**Town of Kittery  
Planning Board Meeting  
September 26, 2019**

**ITEM 2 – 76 Dennett Road – Site Preliminary Plan Review**

**Staff Review**

OVERALL SITE PLAN  
**C5**  
PROJECT NO. 569200  
SHEET 5 OF 25

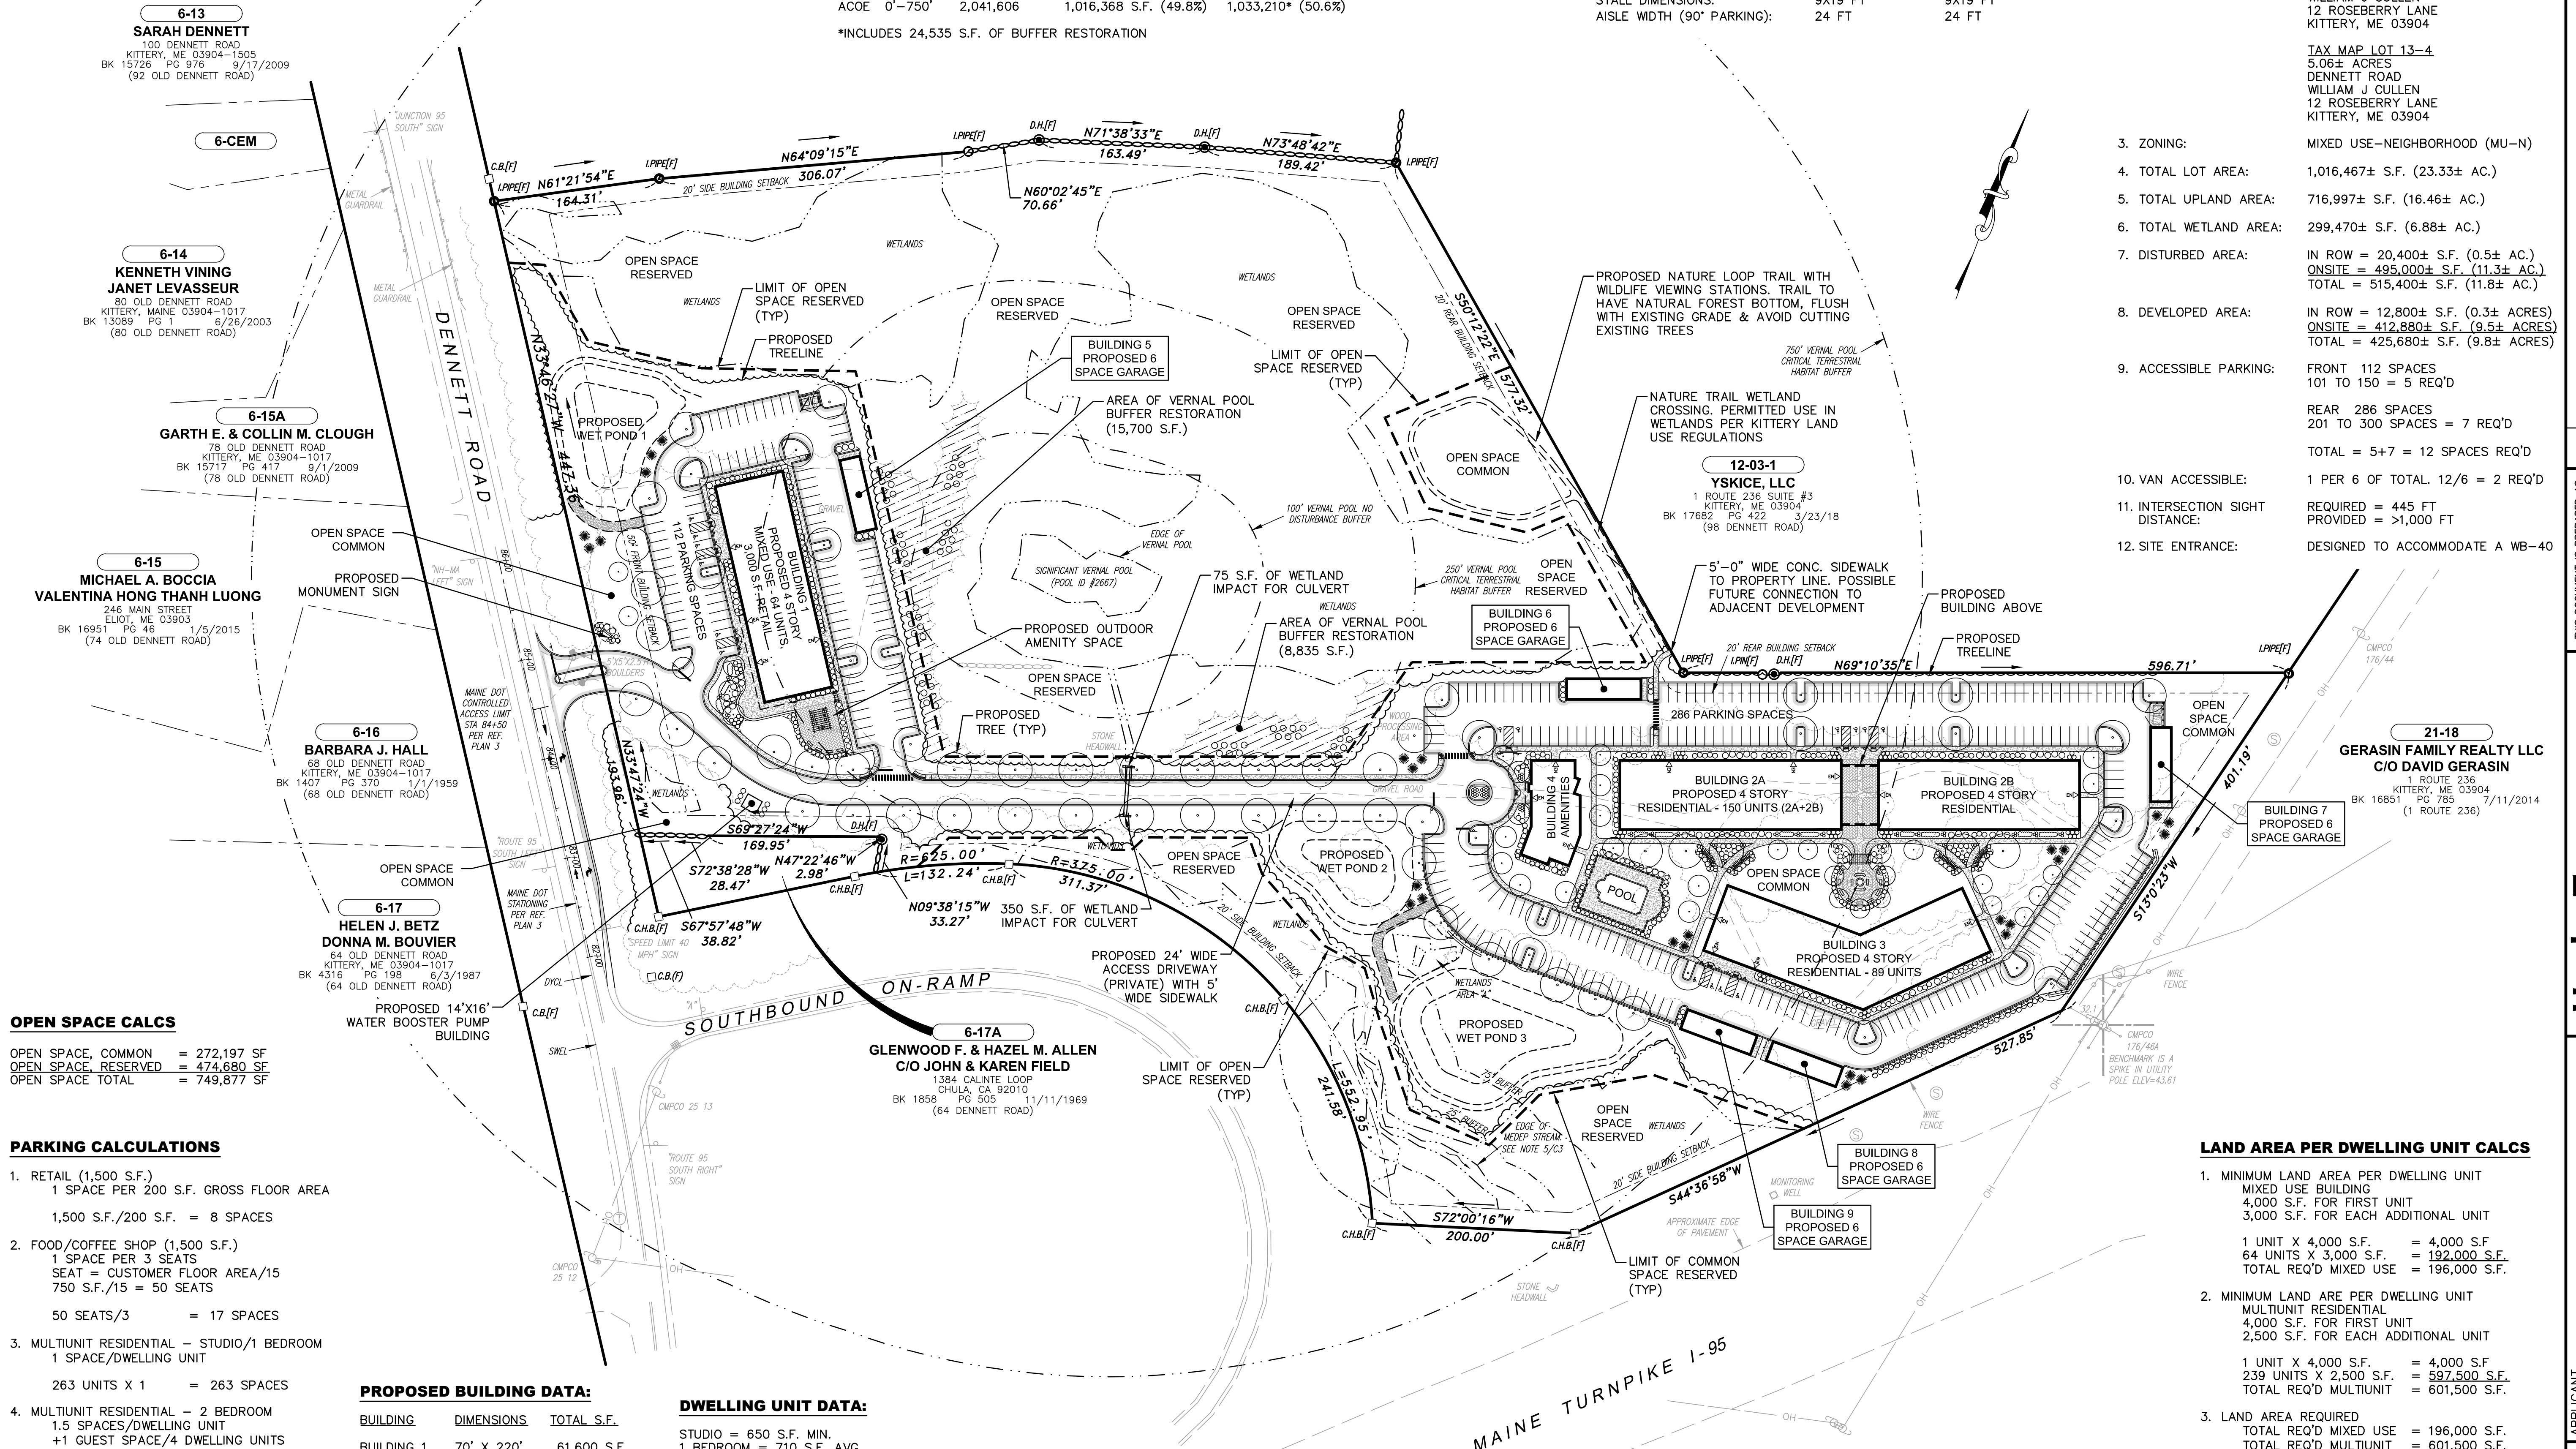
3. Parking calculations are listed on sheet C5 of the preliminary plans. The development will provide a total of 401 spaces:
  - a. Front Building = 114 spaces
  - b. Rear Buildings = 287 spaces

The provided parking meets and exceeds the Ordinance requirements.
